GENERAL MOTORS
DCS 7296
URGENT - DISTRIBUTE IMMEDIATELY

Subject: N252505370 - Service Update
Tail Lamp Water Intrusion

Models: 2026 Cadillac VISTIQ

N252505370 Tail Lamp Water Intrusion

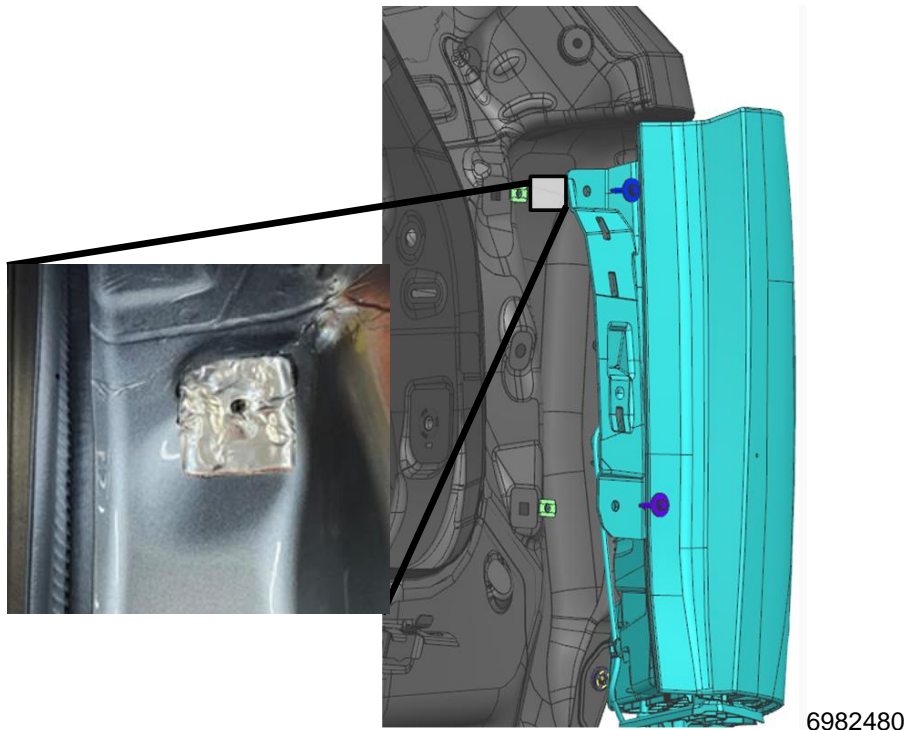
Condition	Certain vehicles listed above may have a condition in which the RH Tail Lamp may not seal properly to the vehicle body, allowing water intrusion into the rear compartment.
Correction	Dealers will add a butyl patch between the RH Tail Lamp and vehicle body at the upper fastener location.

2. Install a butyl patch over the bolt location for the upper rear stop lamp bolt as shown.
3. Reinstall the right rear stop lamp. *Rear Body Structure Stop Lamp Replacement* in SI.
